# CITY OF SANTA FE

# INVITATION TO BID

**23/48/B**

**Title: On-Call Roadway and Trails Construction Services**

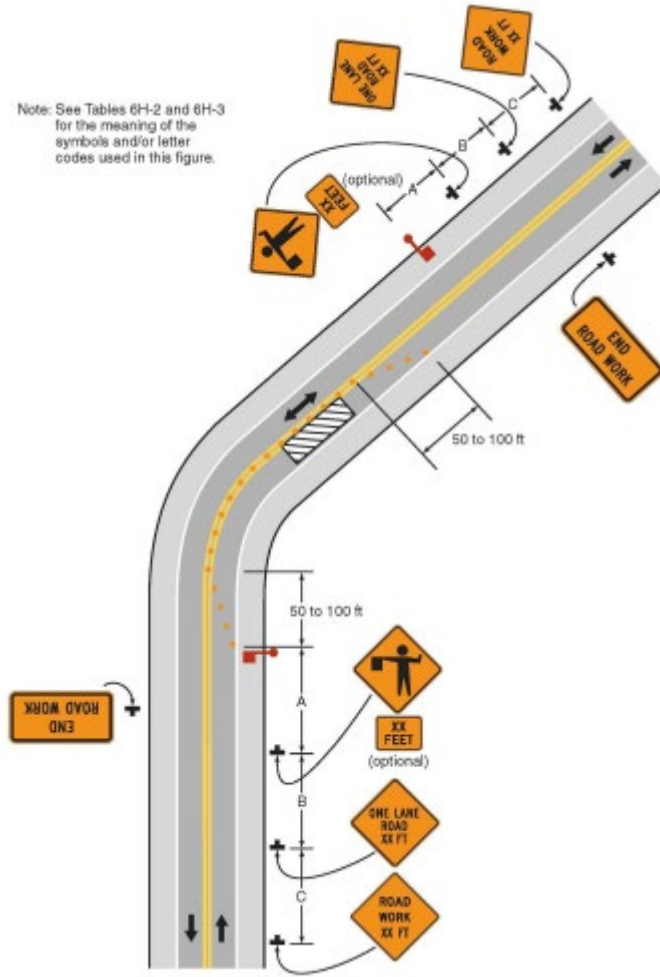
25. The individually priced landscape items on page 12 which I have attached, do you only want unit prices or total prices for each item ?? For example L@ total CY price for a unit price ? Same for the rest of the items, each price, S F price, CY price, or total price for the quantity shown ??

Since this is **lump sum**, please give us the lump sum amount in item 19 Bid # 664000 Landscape Complete. You can derive that amount by determining the total amount for each Line item (L1 through L10) and summing them all up. For e.g. L1 "Clearing and Grubbing" \$2/S.F. multiplied by 48,700 = \$97,400. Please do this for all the items and sum them up. This will be your lump sum amount for item #19 Bid # 664000 Landscape Complete.
